DATE: October 21, 1992

SUBJECT: PAGE CHANGE INFORMATION - RD&D PERMIT APPLICATION

Table 4-3. Predicted Effectiveness of Ventilation System Activated Carbon with Spiked Liquid Effluent Retention Facility Feed. (sheet 1 of 2)

SETTLEMENT SKETCH

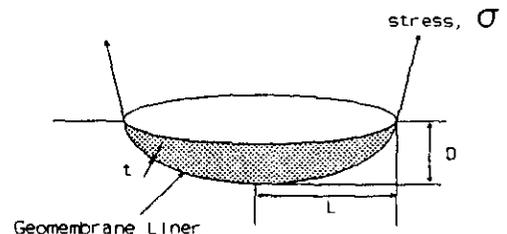
The tensile stress induced in the geomembrane due to the deflection induced by subsidence is calculated with the following modified equation and is illustrated in the sketch.

$$\sigma = 2DL^2p/[3t(D^2 + L^2)] \quad (\text{Equation 1})$$

By substituting this value (1,771 psi) for tensile stress in Equation 1 above, the allowable deflection,  $D_A$ , can be calculated, i.e.,

$$1,771 \text{ psi} = 2D_A(10 \text{ inches})^2(125 \text{ psi})/[3(0.030 \text{ inches})(D_A^2 + (10 \text{ inches})^2)]$$

By trial and error iteration,  $D_A$  is found to be 0.64 inches.

Assuming a safety factor of 2, the allowable deflection of the berm geomembrane due to foundation settlement under the dual tires is 0.64 inches. The "Asphalt Pavement Analysis" in this appendix concluded that the maximum deflection under a dynamic load is 0.013 inches.
